UNECE - TIRExB - Geneve – February, 2010.

**TIR APPROVAL OF A
SPECIFIC CONSTRUCTION
OF ROAD VEHICLES**

(EMPTY SPACES AS A PART OF THE LOAD COMPARTMENT)

Loading option A:

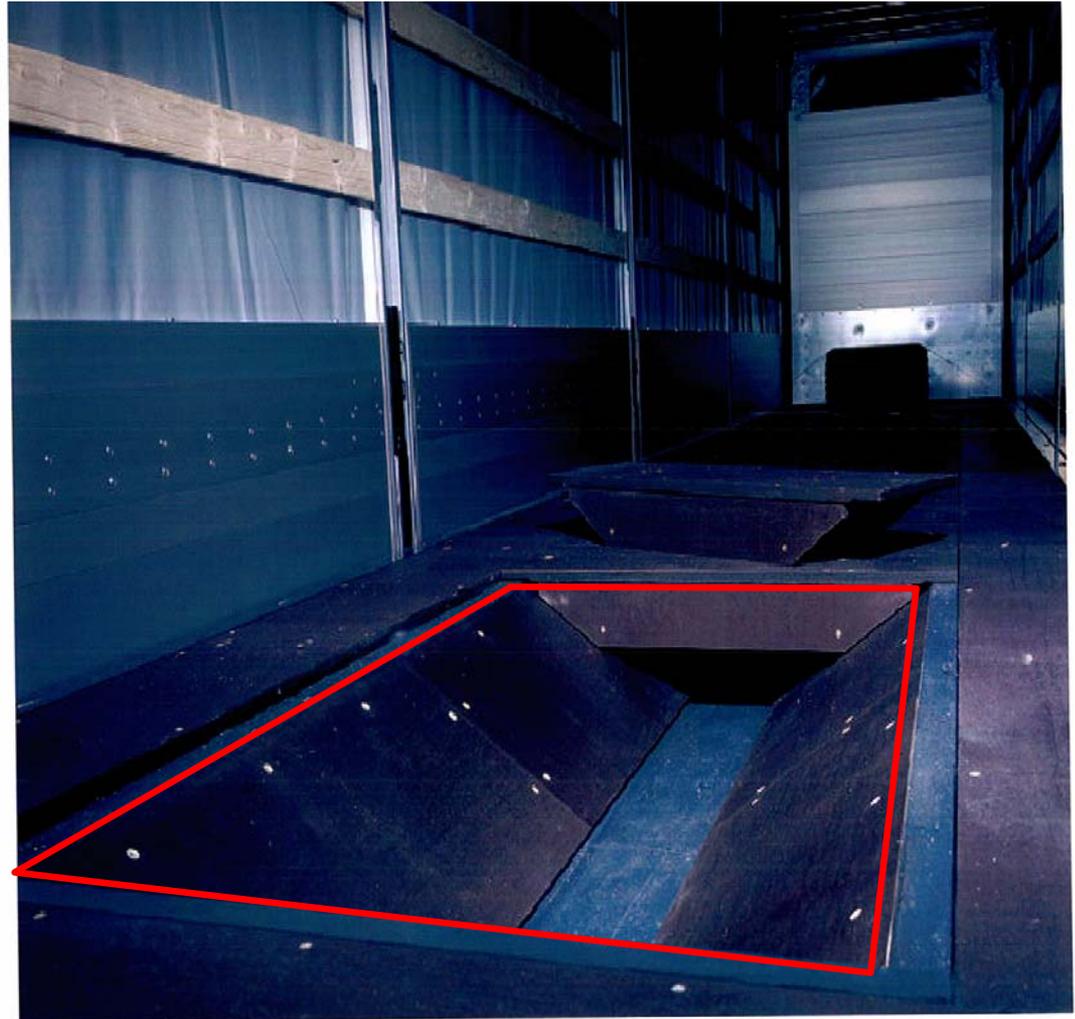
The trough is left open in its entire length, NO floorboards being present inside the load compartment!

There are **NO empty spaces** which can be used to conceal goods.

(Highly inappropriate platform for EUR-pallets or goods in boxes!)

TIR Approval: ✓

Loading option B:

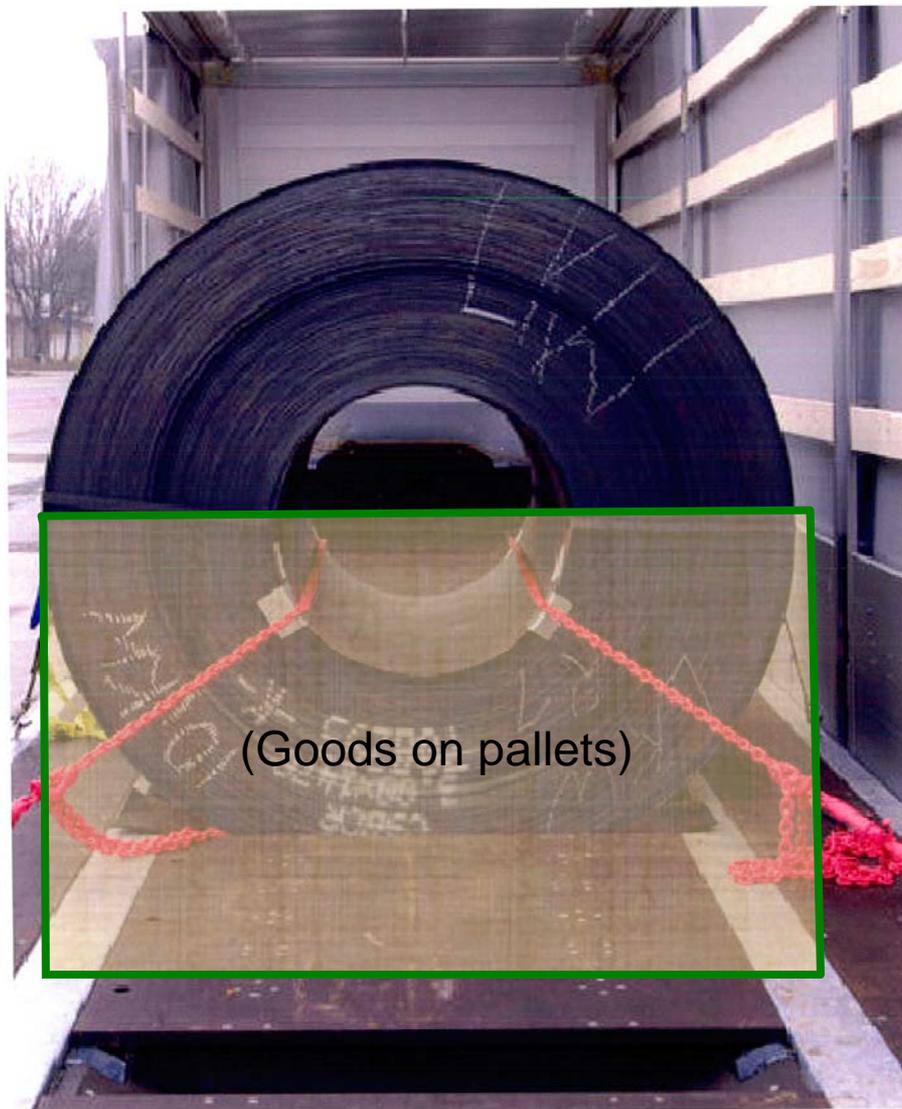
The trough is covered by the goods itself, i.e. a sheet metal coil.

All floorboards left loose;
without goods placed on top:

There are empty spaces – but each individual floorboard can easily be lifted for inspection underneath as well as the trough itself.

Spaces are readily accessible for Customs inspection.

TIR Approval:

Loading option C:

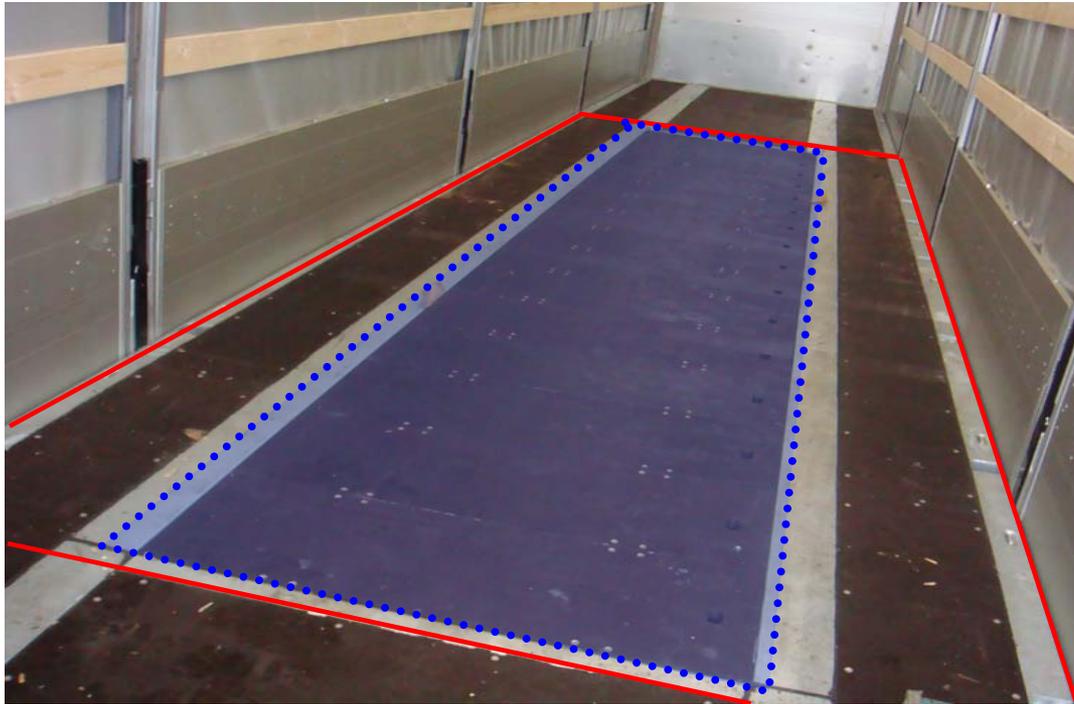
The trough is covered by heavy goods where it is placed. Additional goods placed on top of one floorboard - or across several floorboards:

There are empty spaces – each individual floorboard **CANNOT** be inspected underneath, neither can the trough.

Spaces are **NOT** readily accessible for Customs inspection.

Due to the reinforcement construction, each individual floorboard holds
3 empty spaces underneath!

NOTE: Numbers shall be kept to a minimum!

If a single floorboard is removed, front or rear of the load compartment, only the entire length of the very bottom of the trough can be inspected by simple means, e.g. visually by illumination using a torch. The area marked light yellow on the picture.

The area inside the dotted blue line ***MUST*** be free from goods in order to lift each individual floorboard for inspection underneath. Most likely all goods placed inside the area marked with a full red line must be offloaded, providing access to the loose floorboards and the trough.

TIR Approval:

Therefore this vehicle CANNOT be approved.
